SPEATH ENGINEERING

RE: Port Pheonix Water Way Marina – DCI2023-00054 – Major PD

Please find below responses and commentary to the provided comments from staff in your September 10, 2024 letter regarding the Commercial Planned Development Application for Port Pheonix Water Way Marina (DCI2023-00054).

CONSUMPTION ON PREMISE EXHIBIT
FOR
WATERWAY MARINA
SAFE HARBOR MARINAS
LEE COUNTY, FLORIDA

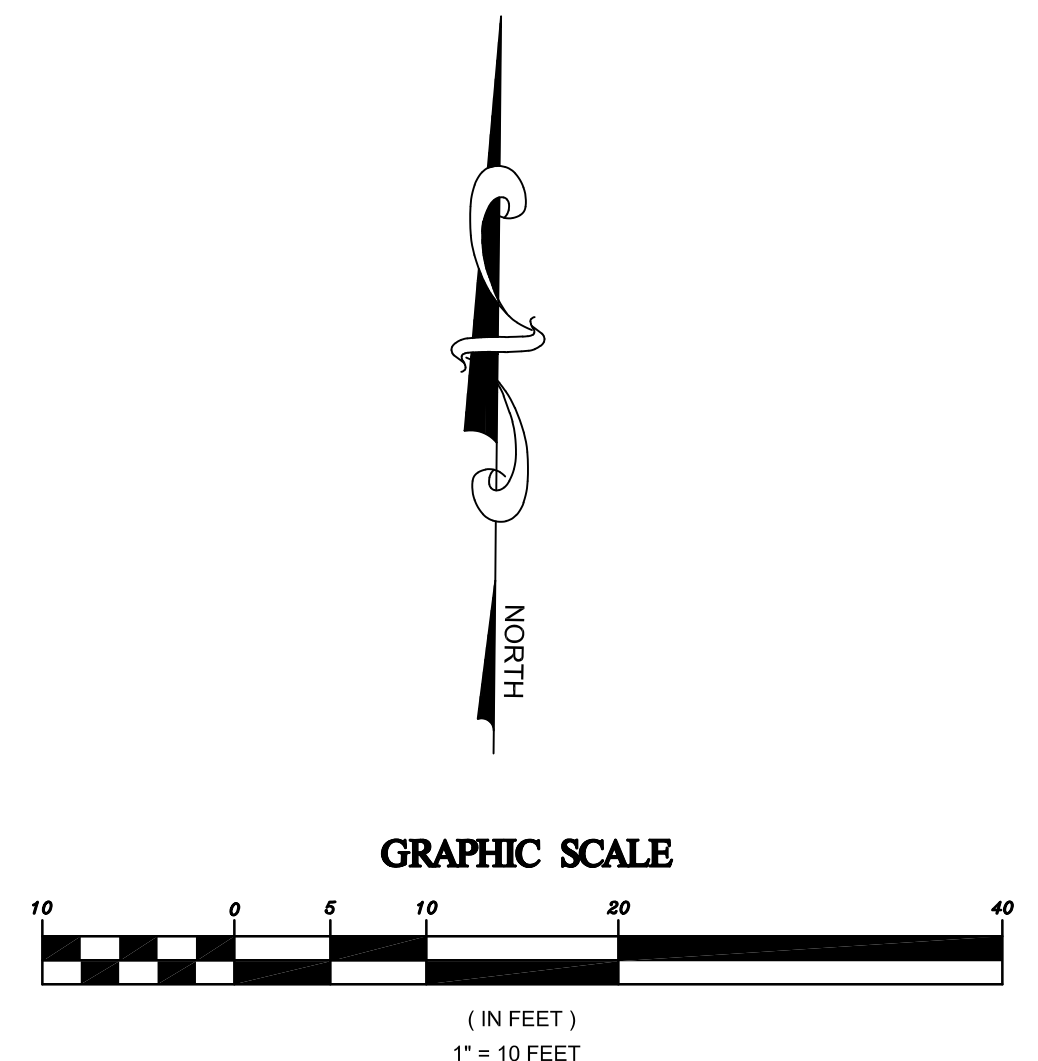
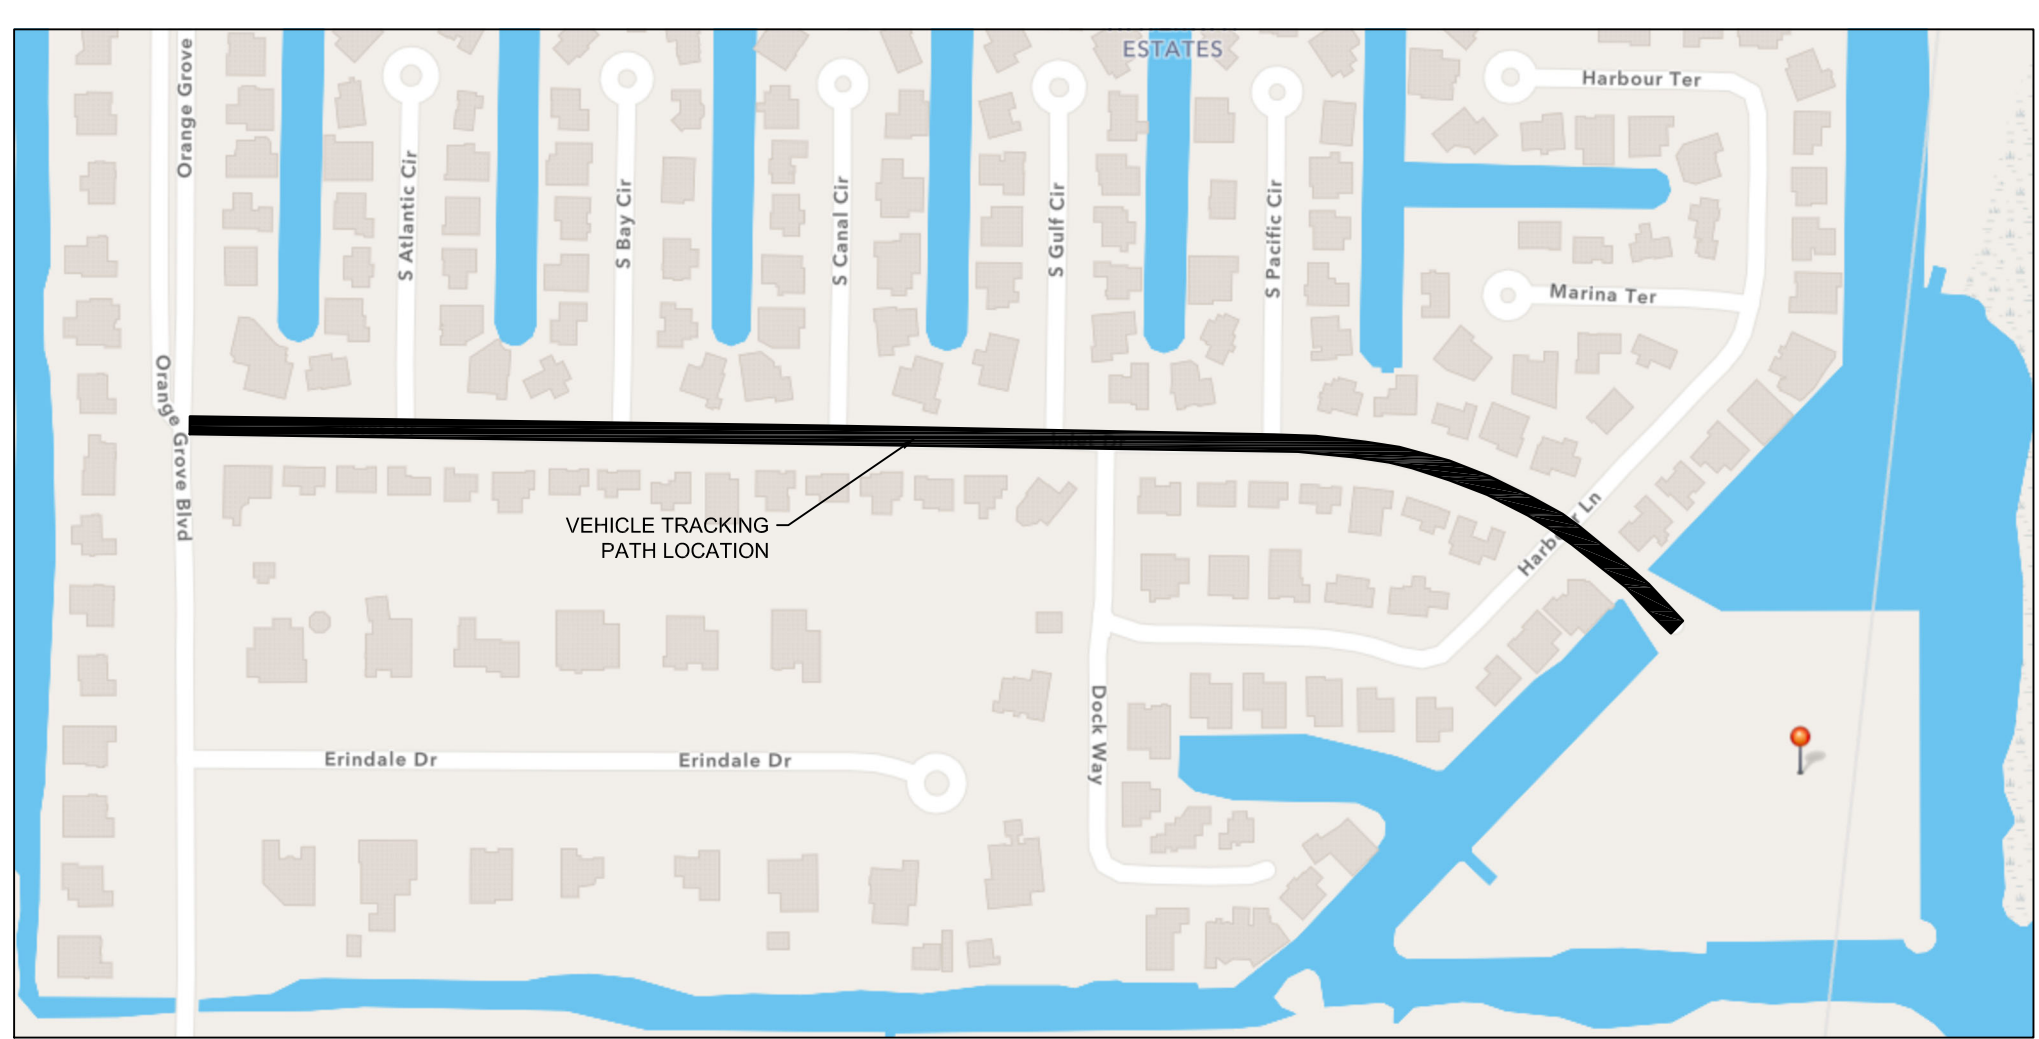
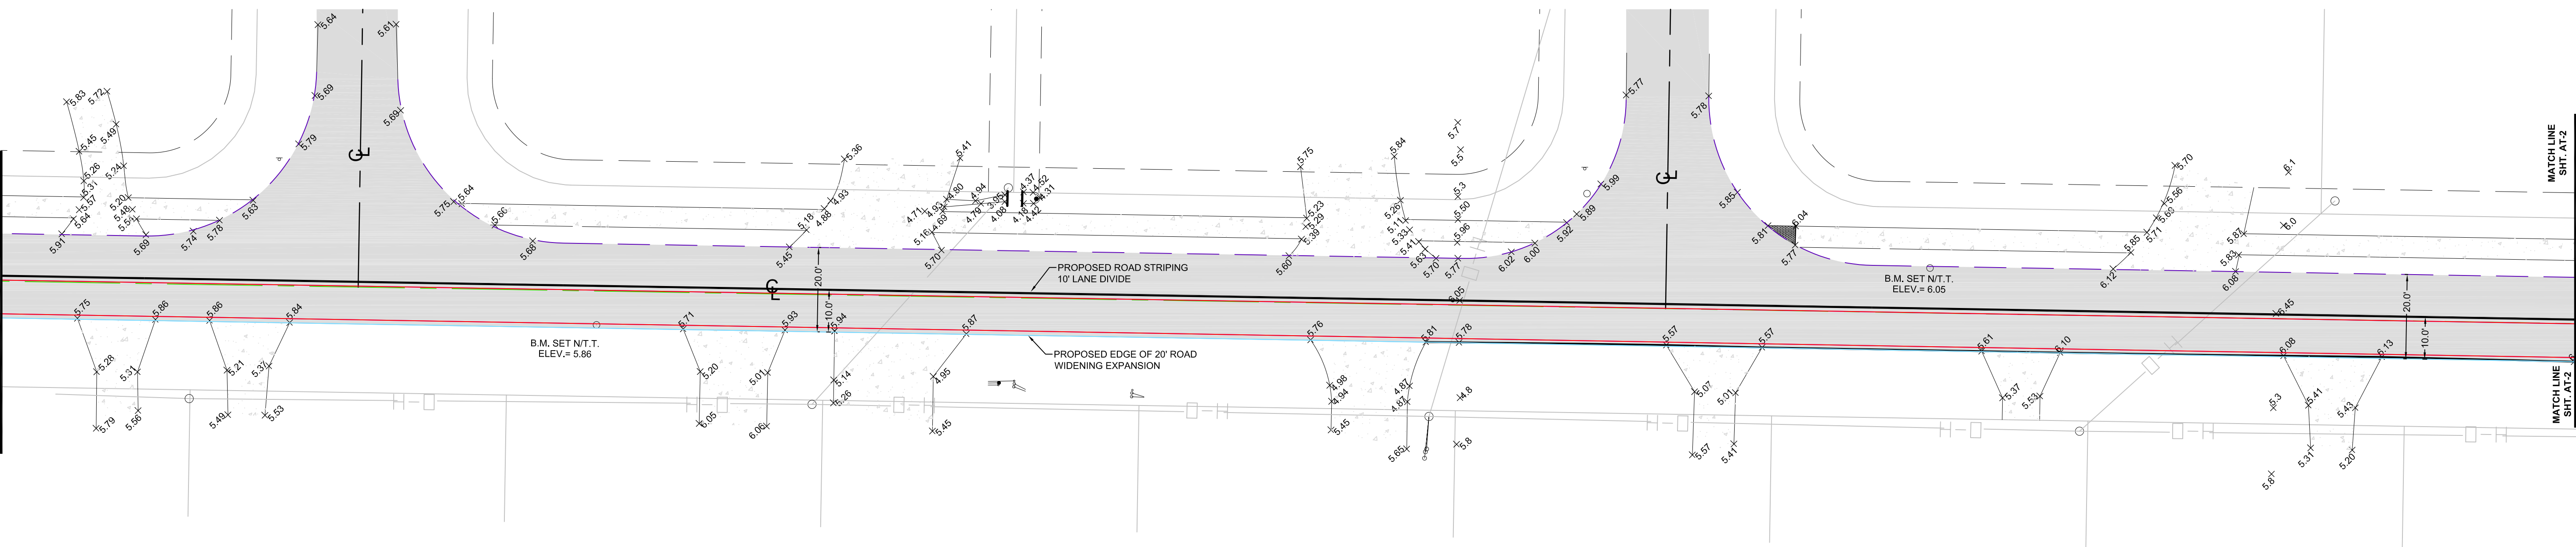
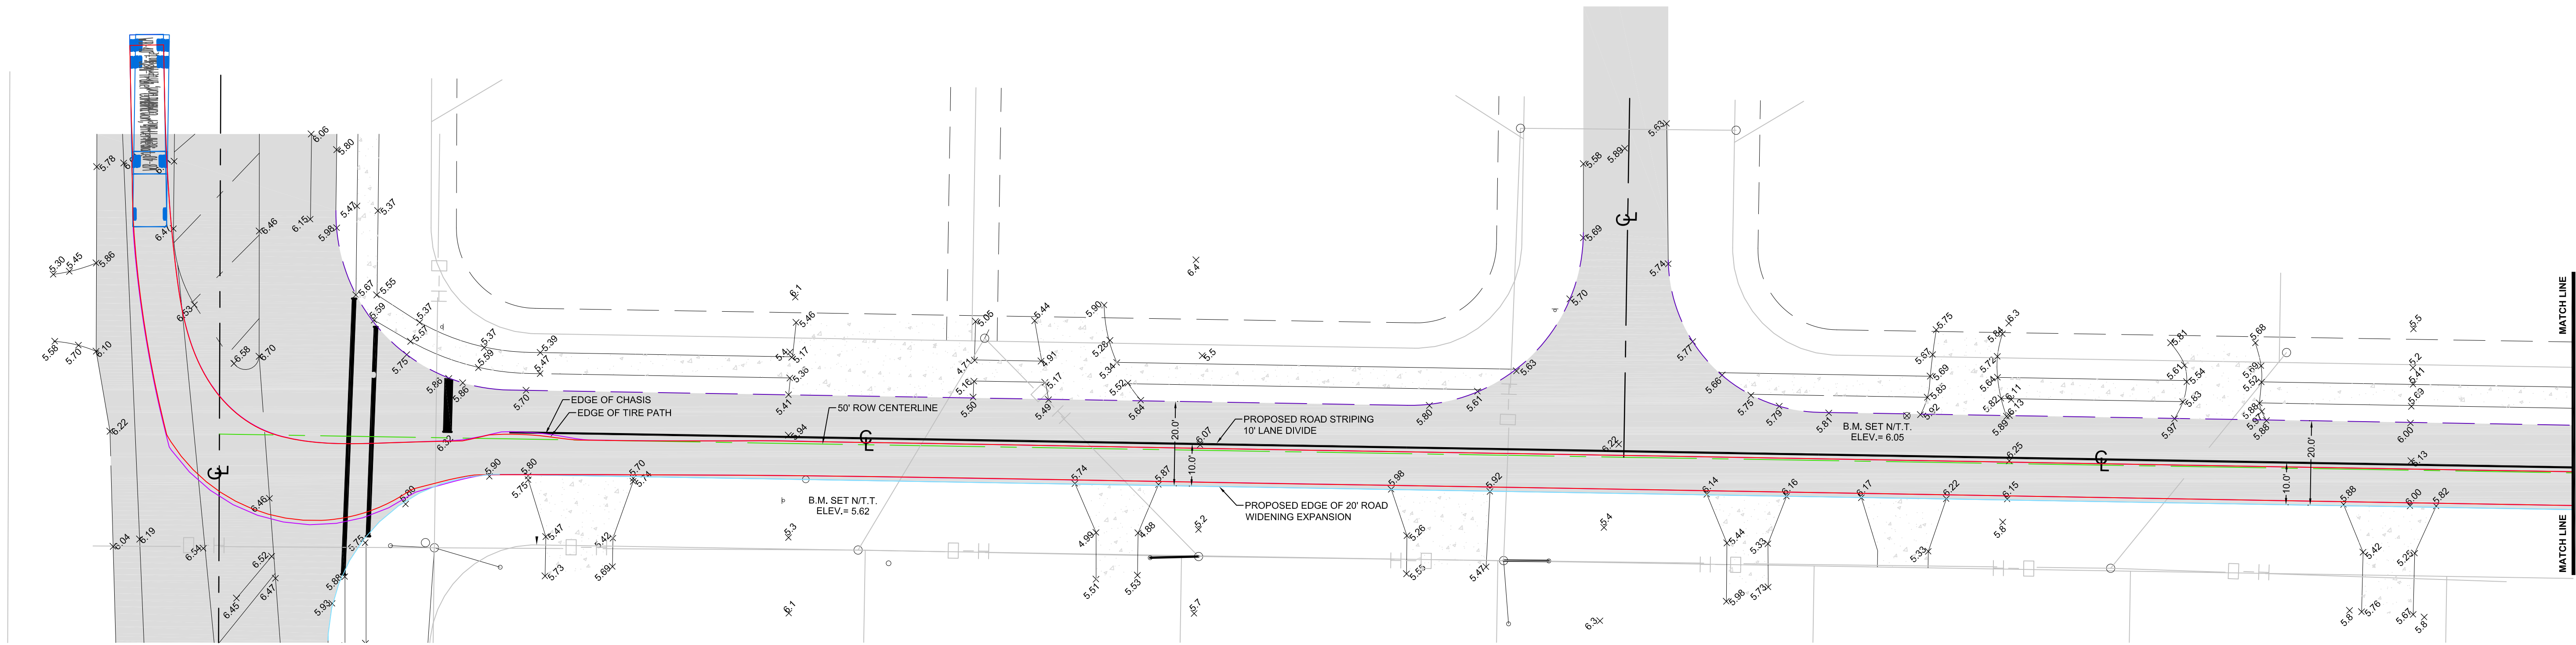
2. *It is the applicant's responsibility to request any approvals required for consumption on premises and provide the required documents in LDC 34-1261 if applicable. The applicant is encouraged to review the land development code requirements and request specific approvals as part of the public hearing process as required. Staff does not have adequate information to evaluate the operation and determine if deviations from the LDC or appropriate conditions are required. Please consider the following: Outdoor Patio Seating Area with COP to be covered? If so, please show this on the MCP. Is there a bar at the private club? Is ordering available from the restaurant for delivery (food/beverage) to the outdoor patio or private club? Is a setback deviation required (34-1264(b)) for COP areas? Is outdoor entertainment anticipated? If so, what are the proposed hours? Are any hours of operation of the private club/outdoor COP proposed?*

Please see attached the COP Summary outlining information from LDC 34-1261 to 34-1265, as well as the updated Consumption On Premises Exhibit, itemizing the relevant locations.
